PLANT HATCH - UNITS 1, 2
NRC DOCKETS 50-321, 50-366
OPERATING LICENSES DPR-57, NPF-5
SUPPLEMENTAL RESPONSE TO STATION BLACKOUT

ENCLOSURE
PLANT HATCH UNITS 1,2
NRC DOCKETS 50-321, 50-366
OPERATING LICENSES DPR-57, NPF-5
SUPPLEMENTAL RESPONSE TO STATION BLACKOUT

SUPPLEMENTAL RESPONSE TO STATION BLACKOUT

ATTACHMENT 1

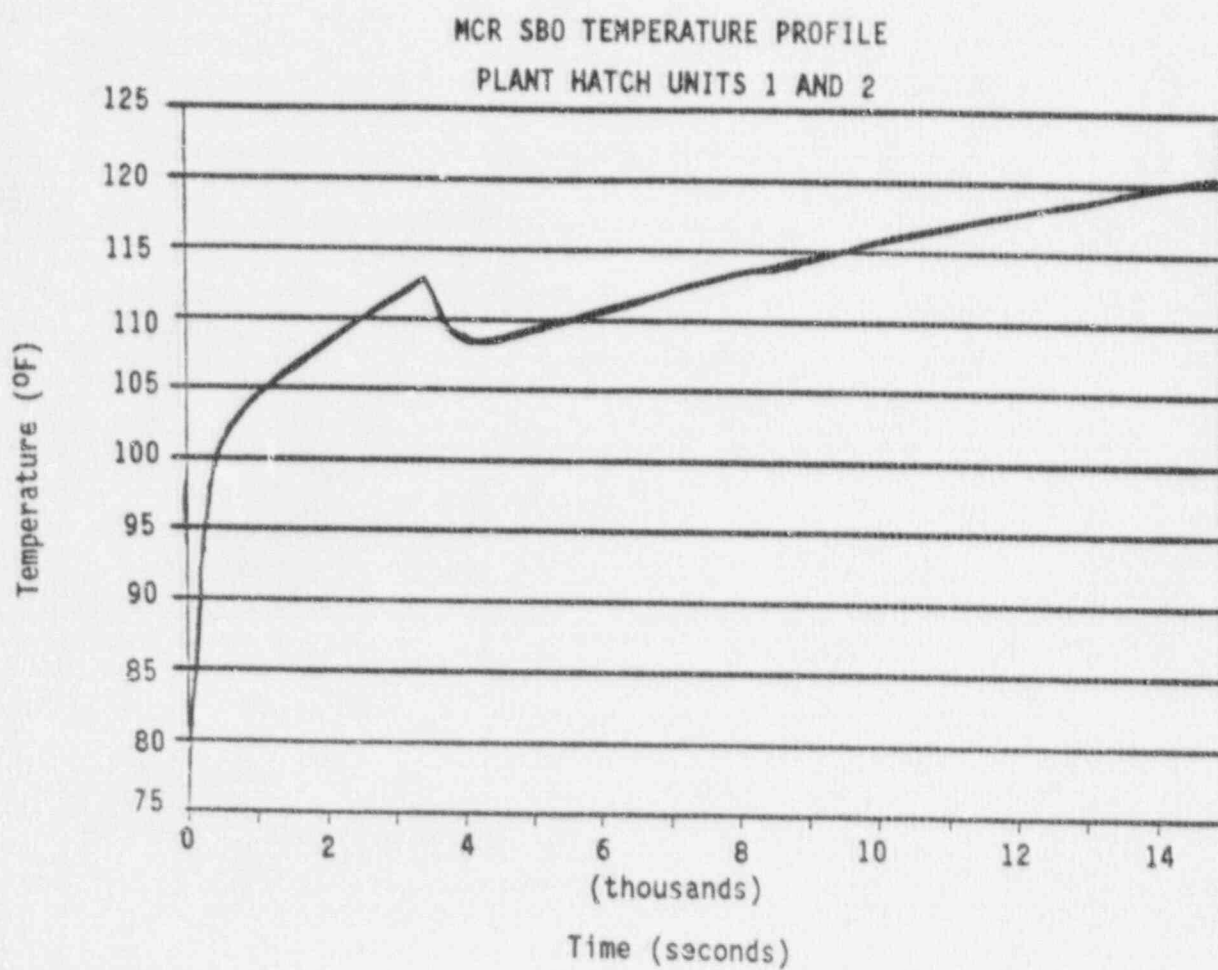
The licensee should reevaluate the effects of loss of ventilation for areas identified in this section and correct the deficiencies. If the licensee's reevaluation shows that additional procedural changes or hardware modifications are necessary to ensure equipment operability in the above-mentioned areas, the licensee should implement the appropriate procedure changes or modifications accordingly. The licensee should submit the results of the analysis, and assumptions used, for NRC staff review, and also maintain these analyses in the documentation supporting the SBO submittal. In addition, procedural controls should be established to open control room cabinet doors within 30 minutes from the onset of SBO to provide adequate air mixing to maintain cabinet temperatures in equilibrium with the control room temperature.

The results of the calculation show the temperature of the MCR is less than 120°F after 4 hours. A curve showing the calculated results is included as Attachment 1. Since the control room is not a DAC, credit was not taken for operators opening the panel doors. However, the back doors of the front main control panels have been permanently removed. Operators will be instructed to open necessary control panel doors within 30 minutes of an SBO event if control room temperature exceeds 100°F. Taking this action at 100°F will limit the temperatures in the panels to well below their qualification temperature.

RHR Pump NPSH Limit

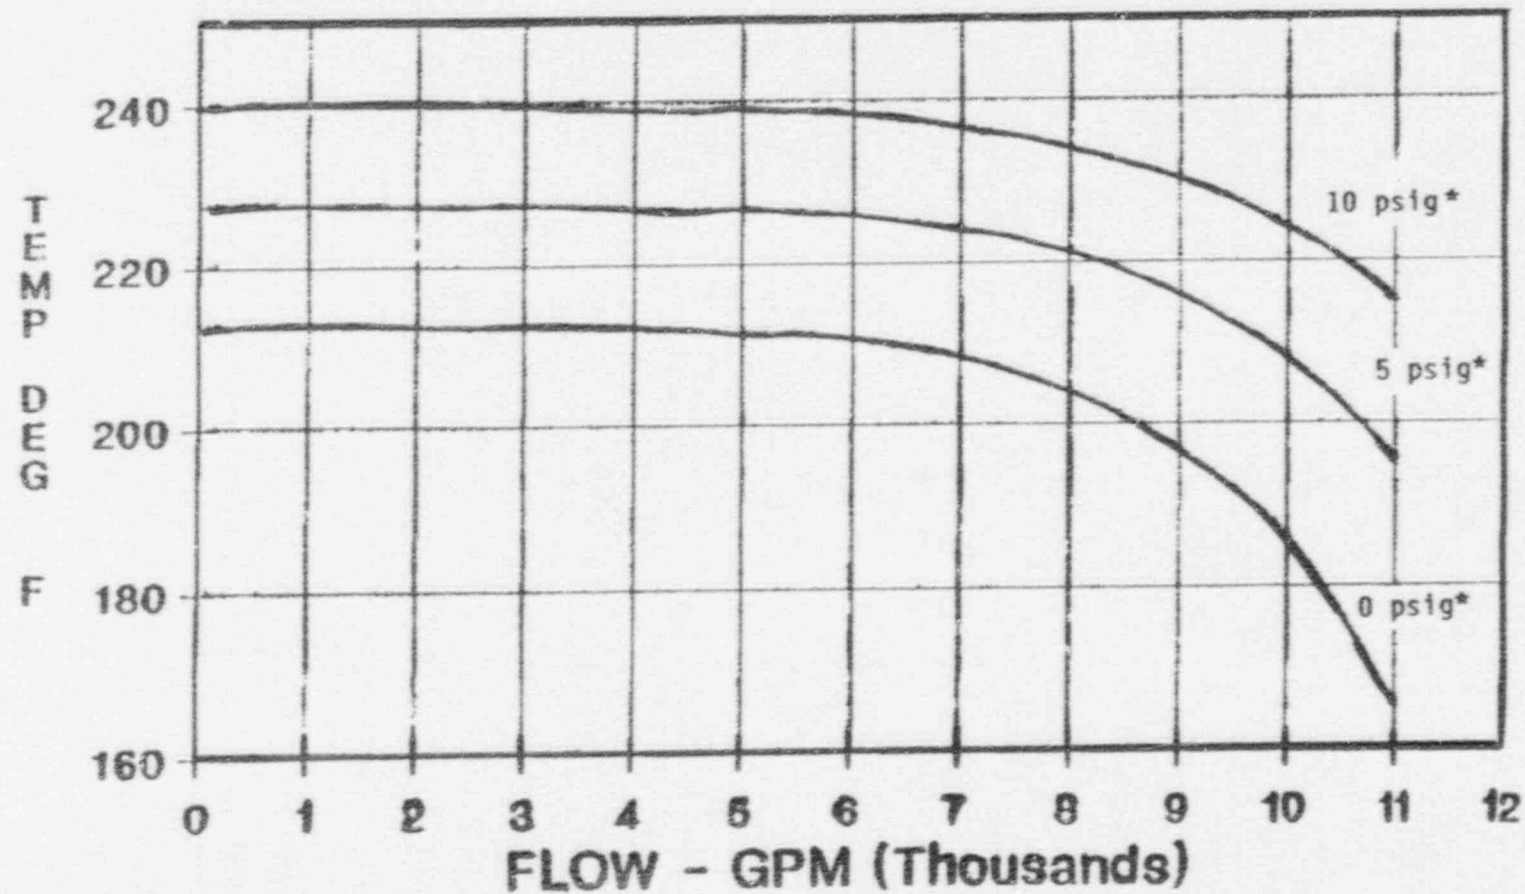
1. Ensure the suppression pool temperature rise will not cause operability problems for RCIC.
2. Ensure adequate net positive suction head (NPSH) is available for the low-pressure pumps after 4 hours without suppression pool cooling. (NRC SER Attachment 1 references a 200°F limit on bulk suppression pool temperature.)
3. SER Attachment 1 identified the scenario when SPC is placed in service 1 hour after the onset of SBO and requested GPC provide a clear description of the procedure guidance regarding RPV depressurization during SBO, consistent with the assumptions used in the supporting analysis.
4. Identify the proper HCTL curve and whether local (versus bulk) pool temperatures were considered in the HCTL development.

Adequate NPSH will be available for the low-pressure RHR pump, even after 4 hours without suppression pool cooling. The Appendix R analysis used for the coping approach references a 200°F bulk pool temperature limit at 0 psig, but calculates a 211°F peak pool temperature at 8 psig. RHR pump operation is permitted at higher pool temperatures if torus pressure is above atmospheric pressure. The EOPs provide guidance on permissible pump flow rate at a given pool temperature and torus pressure. Attachment 4 of this enclosure provides an example of such a curve. Operating the RHR pumps within this guidance ensures adequate NPSH will be available and decreases the importance of an analytically-calculated peak suppression pool temperature.

HEAT CAPACITY TEMPERATURE LIMIT

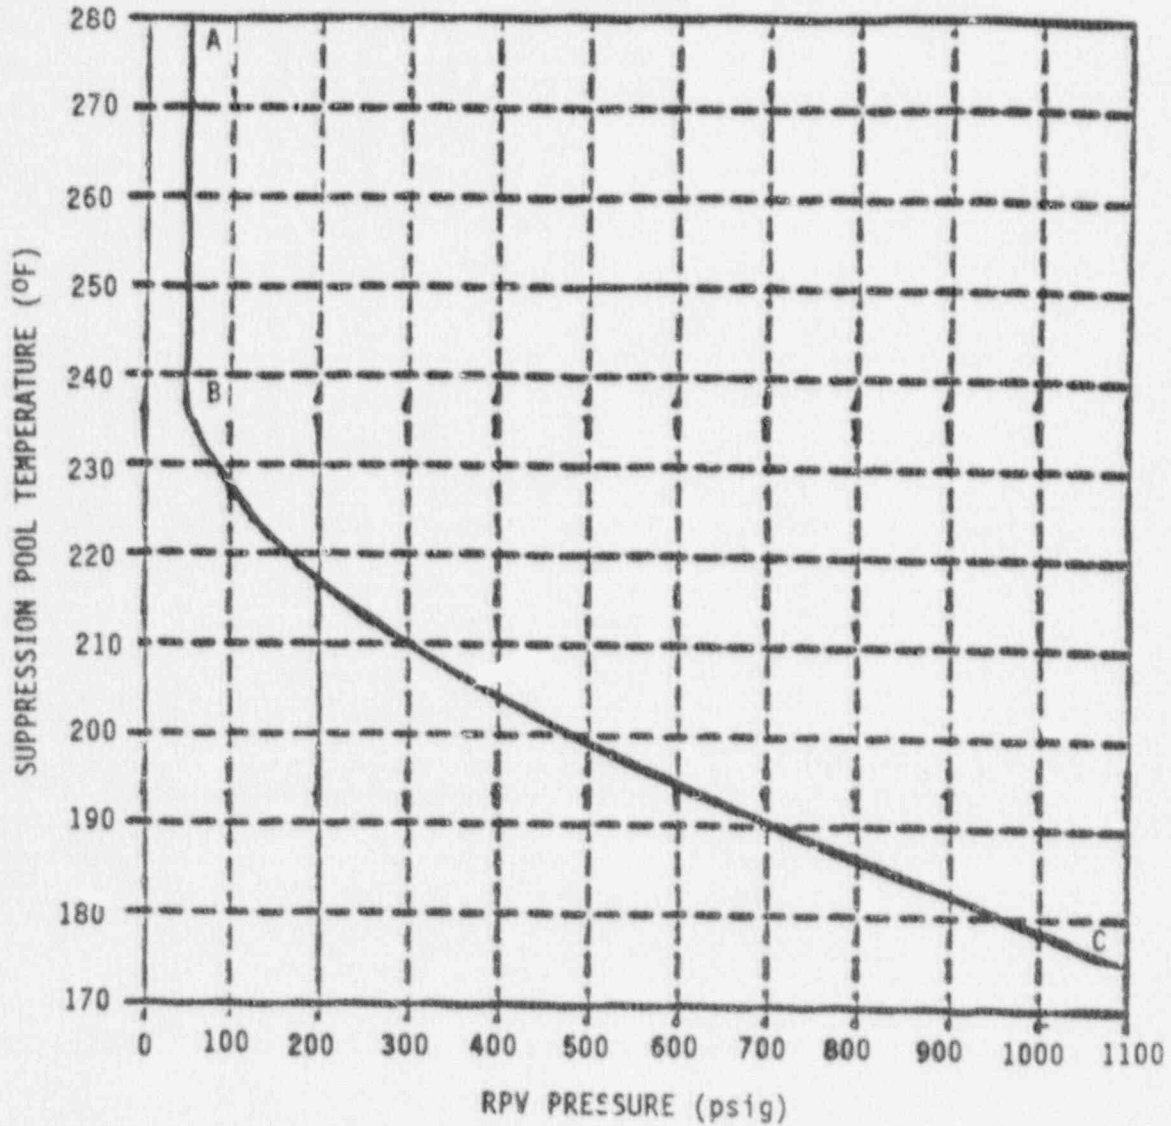
The Licensee should provide a clear description of the procedural guidance to the plant operators and define the approach that will be used to cope with an SBO event. After establishing this approach, the licensee should determine the peak suppression pool temperatures, taking into account localized suppression pool temperatures and using the correct HCTL curve. The licensee should submit the results of the analysis and the assumptions used for NRC review. The procedural guidance, assumptions, and supporting calculations should also be included in the SBO supporting documentation to be maintained by the licensee.

The HCTL is defined as the highest suppression pool temperature at which initiation of RPV depressurization will not result in exceeding either the suppression pool design temperature or the primary containment pressure limit before the rate of energy transfer from the RPV to the containment is within the capacity of the containment vent. The temperature is a function of RPV pressure, and the limit is utilized to preclude failure of the containment or equipment necessary for the safe shutdown of the plant. The HCTL curves for Hatch Units 1 and 2 (Attachments 5 and 6, respectively) are presented in the plant EOPs. The HCTL curves are revised in response to plant modifications, and new or revised EPG guidelines. Plant EOPs will always contain the latest HCTL curve for each unit.
